Solicitation Addendum

Addendum No.: 3

Solicitation Title: Phase 1 of Seacrest Beautification

Addendum Date: August 31, 2017

EXHIBIT A, DRAWINGS, COVER SHEET

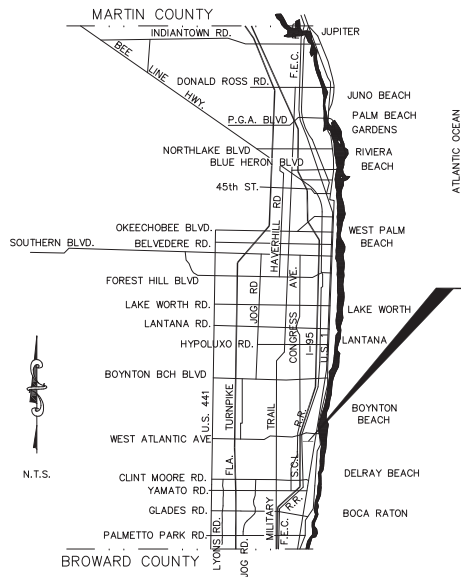
Q18. Sheet C-4: The limits of Construction shown at George Bush Blvd do not include the areas shown on C-16 which call for new loops and pedestrian signals south of the BEGIN PROJECT STA 36+18.66. Please clarify. Also, it appears the loops south of George Bush Blvd (Labeled L-6 on Sheet C-16) were installed in Phase 0. Please confirm that these are not required to be reinstalled during this Project.

R18. Exhibit A, Drawings, Cover Sheet, Sheet C-4, and Sheet C-13 are revised per this Addendum No. 3.

SHEET:
C-5

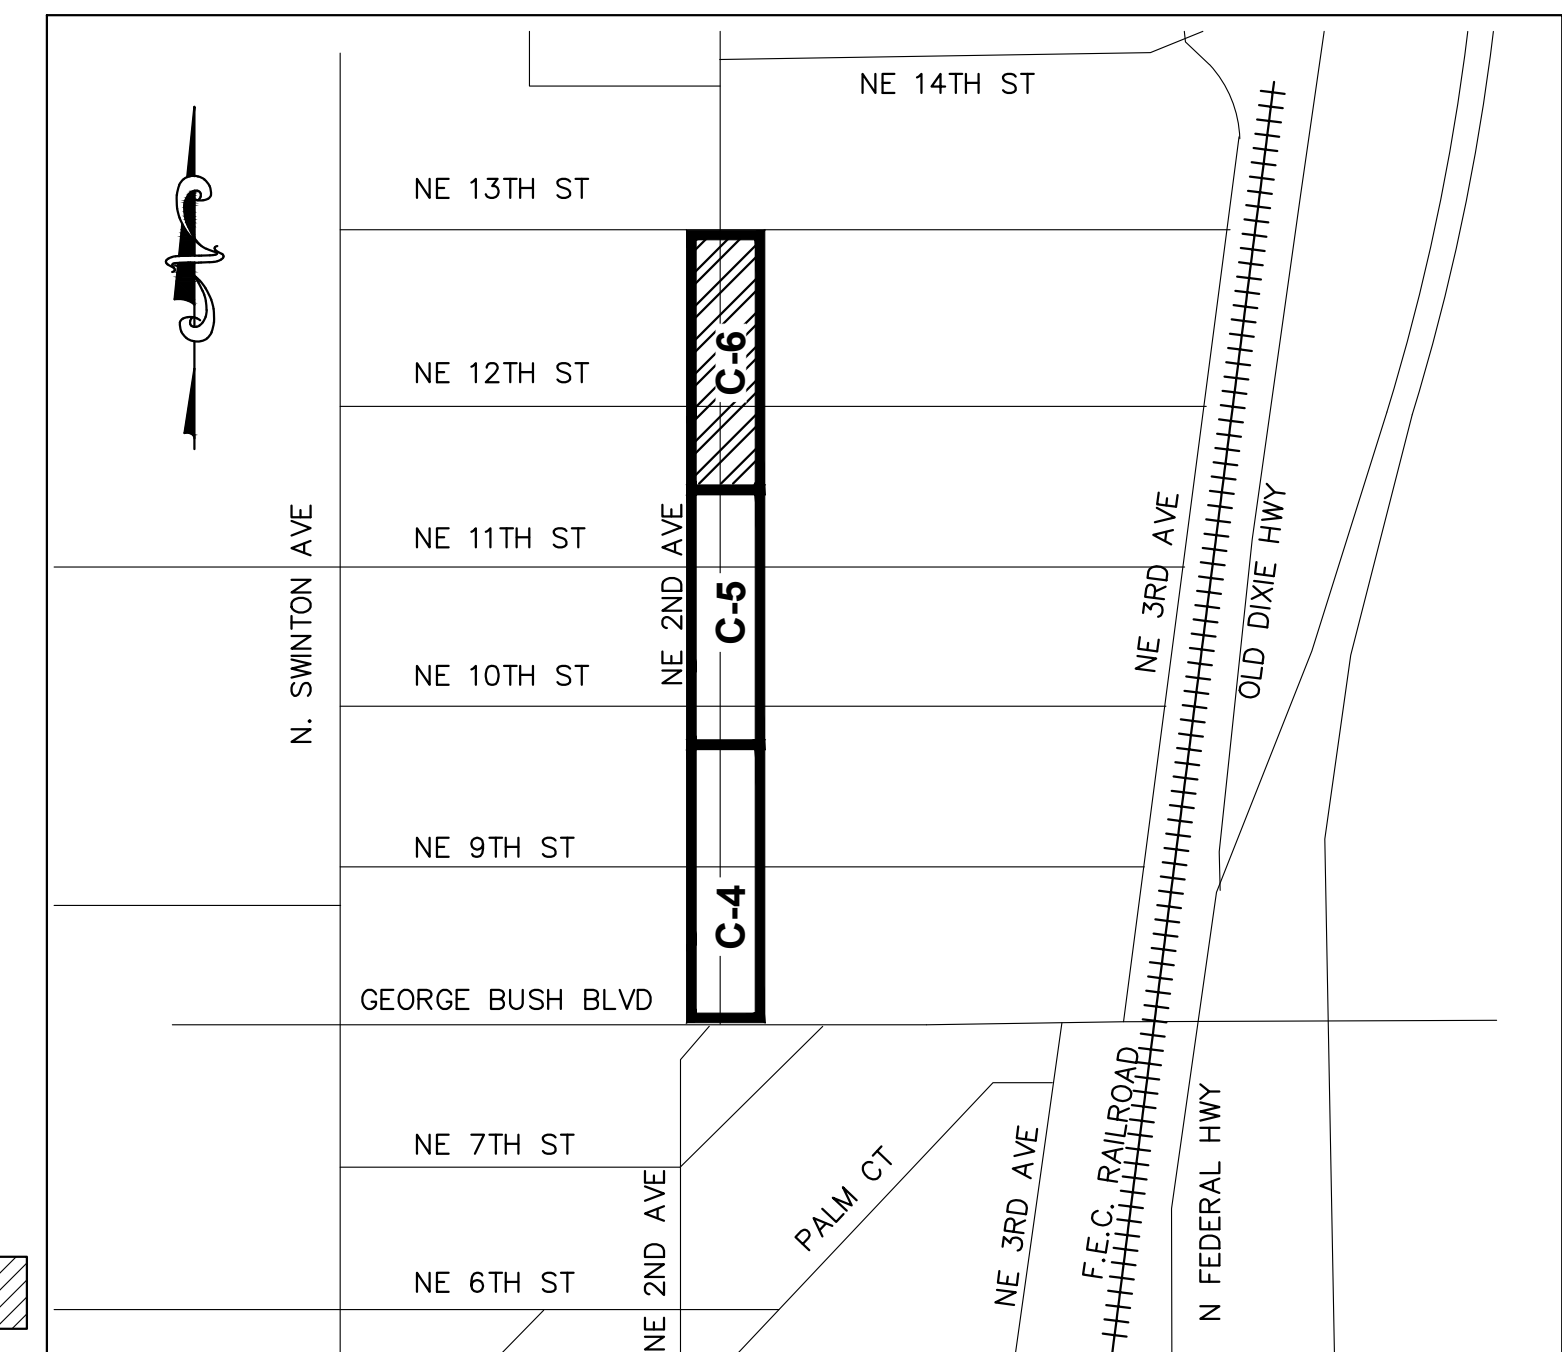
Q20. Please review the plan sheets C-4 through C-6 and pay specific attention to the “Proposed Reconstruction Shoulder” legend marking. There are areas on the West side of the road between intersections of NE 9th, NE 10th, NE 11th and NE 12th streets which appear to be widened but lack the markings to designate this as such. While we believe the intent is to reconstruct this area, we are asking that the City provide clarification for all bidders.

R20. Exhibit A, Drawings, Sheets C-4 through C-6 are revised per this Addendum No. 3.
